IKARUS C42B: BIG wheel axle

All IKARUS C42 B with the new BIG brake, serial numbers 0302-6476 to 0405-6604 and a gusset plate 5 mm thick.

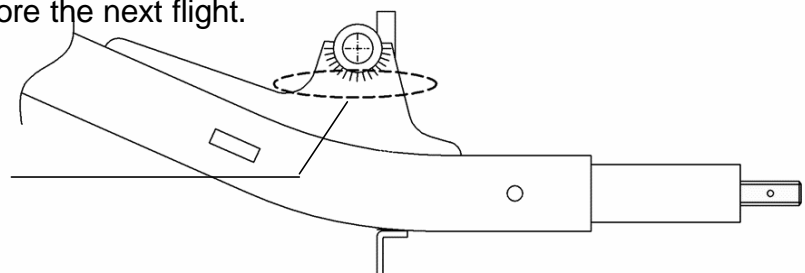
A gusset plate connecting the wheel axle to the shock absorber has ruptured on a wheel axle with the new BIG brake and a gusset plate 5 mm thick. This can result in a failure of the main landing gear.

1. Carry out an inspection of the gusset plate for cracks according to the instructions below.
2. Include this inspection in the normal 50 hour inspection.
3. Replace the wheel axle if necessary.

In order to carry out the inspection, the wing must be lifted and the lower M10 hexagonal bolt of the shock absorber loosened. The examination must be carried out using a magnifying glass with a tenfold enlargement. Should cracks be found, the wheel axle must be replaced before the next flight.

Check this area for cracks

After completing the inspection, the screw should be re-tightened with a torque of approx. 20 to 25 Nm. The work may be carried out by a qualified person.
